vDrive®

vDrive 2.0 — JD Minihopper Rear Post Modification

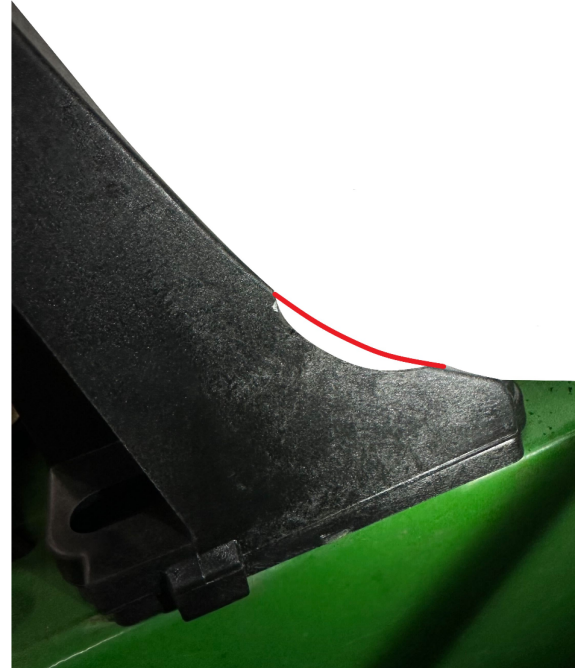
Due to small variances in manufacturing tolerances, vDrive 2.0 may occasionally interfere with the rear post on JD minihoppers. If interference is present (below, left), use a dremel or cutting tool to modify the bracket as shown (below, right).

Completed Modification
